**Subject: Beaver Valley Power Station, Unit Nos. 1 and 2
BV-1 Docket No. 50-334, License No. DPR-66
BV-2 Docket No. 50-412, License No. NPF-73
Responses to a Request for Additional Information in Support of License
Amendment Request Nos. 302 and 173**

Response to Request for Additional Information (RAI)
Beaver Valley Power Station, Unit Nos. 1 and 2 (BVPS-1 and 2)
Extended Power Uprate (EPU)
Docket Nos. 50-334 and 50-412

Figure 1
BV-1 MSVH Temperature vs Time

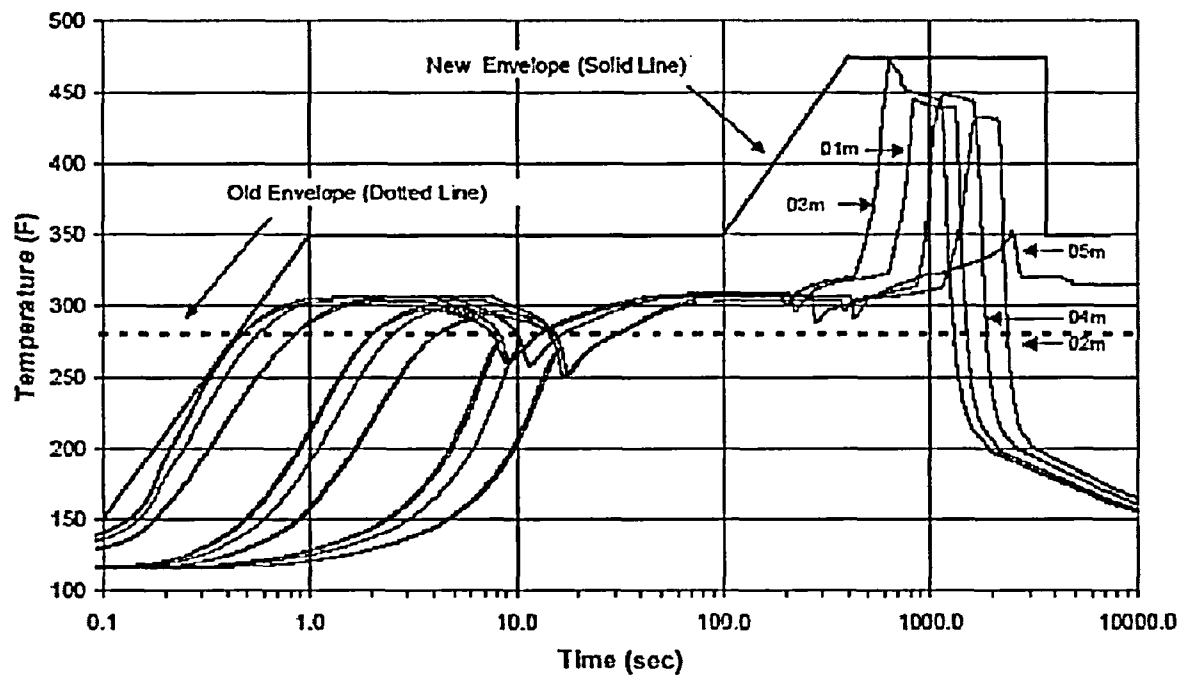
- A. Provide a comparison of the revised inside containment LOCA/MSLB temperature and pressure profiles to the current profiles.
- B. Provide a comparison of the revised temperature and pressure profiles inside the main steam valve houses and the service building to the current profiles.
- C. Describe the scaling factors used to determine the gamma and beta radiation total integrated dose (TID) values for post-EPU conditions.
- D. Describe the shielding/reduction methods used for beta radiation for post-EPU equipment qualification, including the junction boxes with weep holes or open sides.
- E. This section indicates that the alternative test data was used to qualify equipment. Provide details of the alternative test data.

- A. Revised EQ temperature profiles were developed to address the combined effects of containment conversion (CC), BVPS-1 replacement steam generators (RSGs) and extended power uprate to 2900 MWt (EPU). These profiles were included as Figures 7-1 for BVPS-1 and 7-2 for BVPS-2 in Enclosure 2 to the CC LAR 317/190 submitted in FENOC letter No. L-04-073 dated June 2, 2004.

Figure 1 is the BVPS-1 MSVH temperature profile
